May 24, 2021 ADI Letter #4

Noise impacts near Foxcroft Lake and Dunn residence, additional mitigation, and buffer clarification

MEMORANDUM

To: Sam Bratton (Wake Stone)
From: Erich Thalheimer (WSP)
Date: August 9, 2021
Project Name: Wake Stone Quarry Noise
Project Number: 31402799.000
Subject: Responses to DEMLR ADI Noise Questions 5/24/21

Updated Figure 14. Quarry Site Isopleth Sound Difference Contours (Future - Existing)

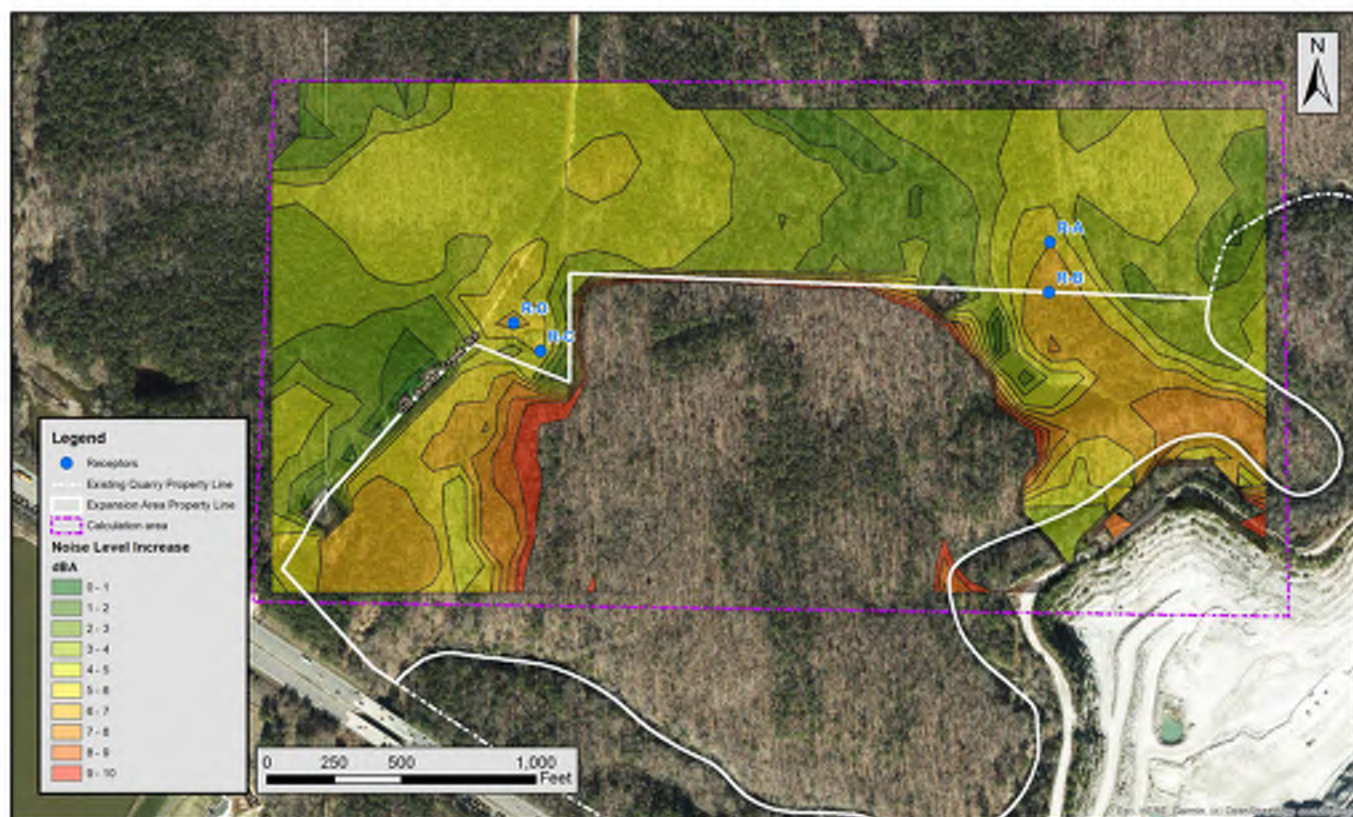
1. *In your report, "Wake Stone Triangle Quarry Expansion Acoustical Study," on page 28, Figure 14 shows an isopleth depicting the sound increase between existing and future conditions. The greatest noise impacts off the property occur across Foxcroft Lake and at the Dunn residence. Based on Figure 14, there is concern that the noise from the quarrying operation may have an impact on the Park. The Division understands that the isopleths in Figure 14 were developed using conservative modeling and did not take into consideration vegetation.*

- A. *Please supply a written explanation as to how the current vegetation on the east side of Foxcroft Lake would affect the noise impact that is being shown in Figure 14. In addition, please propose other mitigating devices needed to reduce the noise impacts on the east side of Foxcroft Lake.*

- B. *The Dunn residence seems to be an area of offsite high noise level increase. Please provide either additional enhanced mitigation to the proposed plan or supply a written explanation as to how the proposed mitigation measures will adequately protect the Dunn residence.*

It is important to note that the isopleths illustrated in Figure 14 of the "Wake Stone Triangle Quarry Expansion Acoustical Study" depict only the Cadna-A Model suggested potential increase of quarry-related noise by comparing modeled future quarry noise levels to modeled noise levels attributable to present day quarry activities. It does not represent an increase between existing and future conditions for **all noise sources**, including airport and interstate highway noise.

The attached memo from Erich Thalheimer (WSP) dated August 9, 2021, addresses the effects existing vegetation on the east side of Foxcroft Lake might have on quarry noises experienced in Umstead State Park. This vegetation will primarily provide a visual screen of proposed future quarry activities from the small area of concern northeast of the lake.

The Cadna-A noise model indicated that the dominant source of quarry noise in this area was anticipated to be from the proposed use of the existing perimeter road on the north side of the existing quarry pit (Pit 1). To lessen the effects of this model-suggested noise increase on that small section of Umstead State Park immediately northeast of Foxcroft Lake, WSC directed WSP to examine additional mitigation measures that we might employ. Various sound barrier walls were considered and modeled at different locations and heights to achieve a reduction in modeled noise. For the area northeast of Foxcroft Lake, the most effective (and only practicable) additional mitigation was the inclusion of a sound barrier wall along the north side of the existing Triangle Quarry perimeter haul road and across the proposed bridge. Modeling of a 12-foot barrier wall was enough to eliminate the haul route as the dominant source of noise for the area. However, to also function effectively as a visual barrier and to be consistent with the noise barriers previously proposed along the northeast sections of this haul road, Wake Stone will construct a 14-foot acoustical barrier wall as illustrated on the Wake Stone Site Plan set revised August 4, 2021.

This memo is intended to respond to ADI questions from DEMLR dated 5-24-21 regarding concerns of increased noise at the area of Umstead State Park east of Foxcroft Lake and at the Dunn residence adjoining the proposed Pit 2 expansion area. An updated sound isopleth graphic is also included, as requested, to supersede Figure 14 in our (WSP's) original report dated 3/12/21.

Ultimately, the only additional noise mitigation measures that are practicable for Wake Stone to propose included (1) erecting a substantial noise barrier wall along the Dunn property, the northern side of Pit 2, and along Old Reedy Creek Road, in lieu of the previously proposed earthen berm, and (2) a 12 foot tall noise barrier along the end of the haul road and associated bridge to reduce noise affecting the Foxcroft Lake area. **Updated Figure 14** (below) shows the modeled sound isopleth contours with this additional mitigation.

Consequently, Wake Stone is proposing replacing the previously proposed security fence and earthen berm with a decorative DOT-style sound wall from the new driveway entrance at the westernmost point of the property to Foxcroft Lake. The wall would be 16 feet high along Old Reedy Creek Road and along Umstead State Park, and 16 to 24 feet high around the Dunn residence. The originally proposed chain-link security fence would still be utilized along I-40 to Crabtree Creek and from Foxcroft Lake east to Crabtree Creek for security in order to minimize disturbance in these areas. **Updated Figure 14** (below) shows the modeled sound isopleth contours of this newly proposed mitigation.
